# **APPENDIX B**

## **CONSULTATION RESPONSES**

### **Re-alignment of the A737 at The Den, North Ayrshire – Consultation with Statutory Bodies**

**Term Contract for the Management and Maintenance of the Scottish Trunk Road Network – South West Unit – A737 The Den, Dalry  
Pre-application Consultation**

Excerpt No.11 from Scheme Plan  
 (Drg No.030001/002/110/03)  
 Scale: 1 / 200

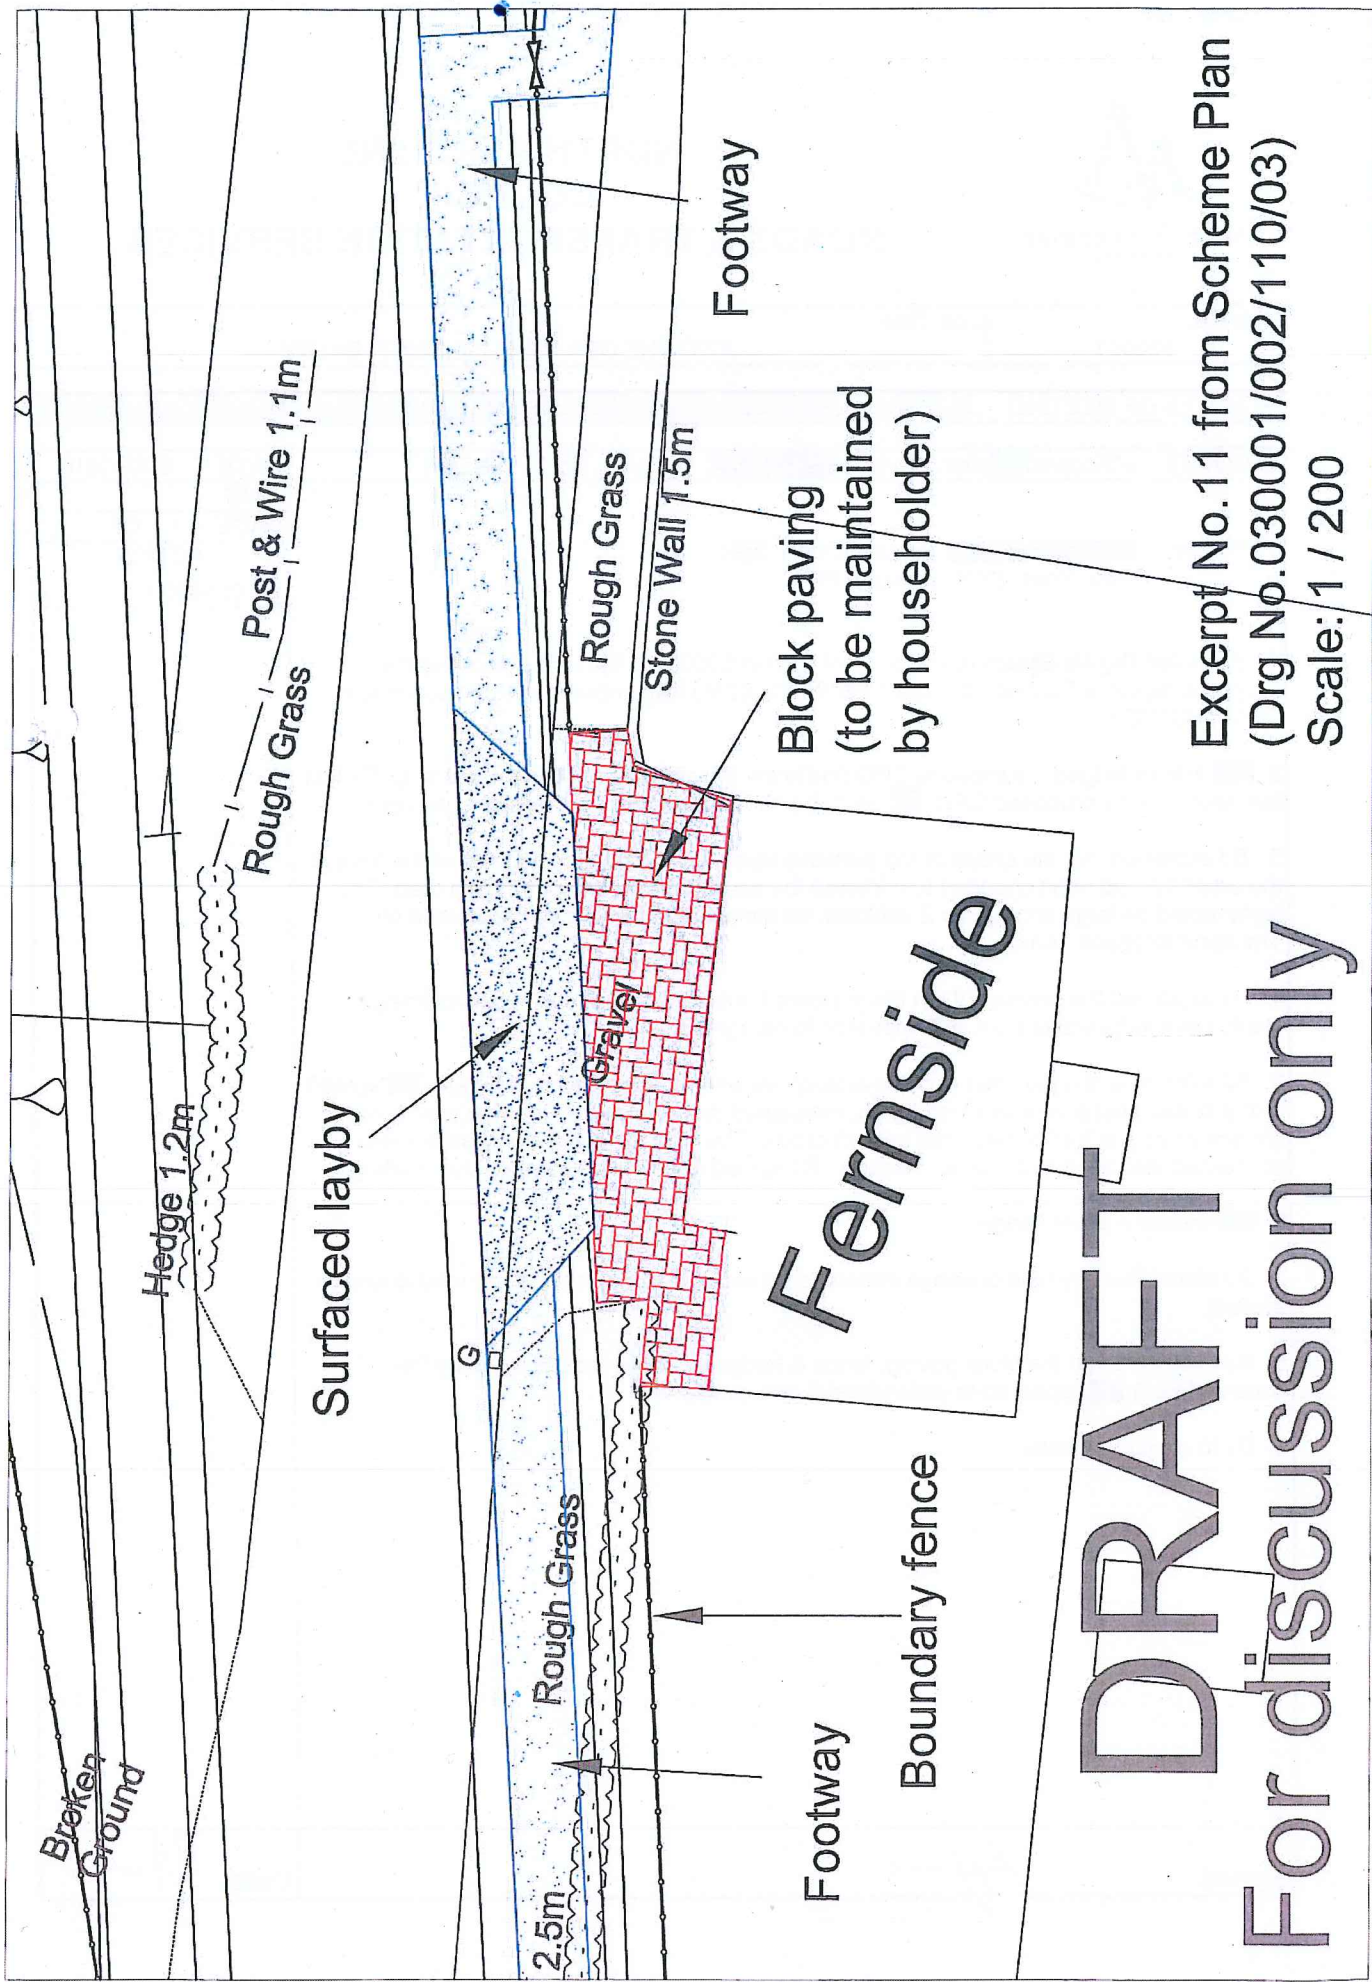
<b>SUBJECT</b> Accommodation Works – [REDACTED], Fernside, No.12 The Den	<b>DATE</b> 01/03/2010
	<b>TIME</b>
	<b>PAGE</b> 1 OF 1
	<b>ACTION</b>
Present: [REDACTED] (Householder) [REDACTED] Bob Jones (NAC Design) [BJ]	<b>Circulation</b>
<p>1. BJ tabled Drg No.Sketch (Excerpt 11 of Drg No.030001/002/110/03) showing the proposed layout at Fernside &amp; Sketch 030001(100216).dwg showing the plot acquired in RC CPO(1990).</p> <p>2. [REDACTED] acknowledged the previous CPO and knew the plot was in NAC's ownership. BJ told her about the TS proposed CPO. [REDACTED] said she had received no compensation as yet.</p> <p>3. BJ explained that the shape of the previous layby, included in the scheme at the front of the property, had been changed to minimise the need to reverse into the main road. The layby would be large enough for 2 vehicles, be surfaced and would be maintained by Transport Scotland / Amey.</p> <p>4. BJ explained the concept of the block paved frontage &amp; that tie-ins/details/drainage would have to be worked out. [REDACTED] appeared to be agreeable.</p> <p>5. BJ referred to the previous accommodation list with regard to fence &amp; hedge. [REDACTED] agreed with a timber post &amp; wire with netting but mentioned that chicken netting was previously chosen since she had at that time kept chickens. This was no longer the case but was concerned that her dog could not 'escape'. BJ agreed to provide a suitable style netting.</p> <p>6. [REDACTED] wished a privet hedge.</p> <p>BJ stated that any land drainage encountered would be connected to the road drainage system.</p> <p>8. BJ explained that the block paving, fence &amp; hedge would be maintainable by the householder &amp; [REDACTED] appeared to understand &amp; accept this.</p> <p>9. BJ to confirm by letter.</p>
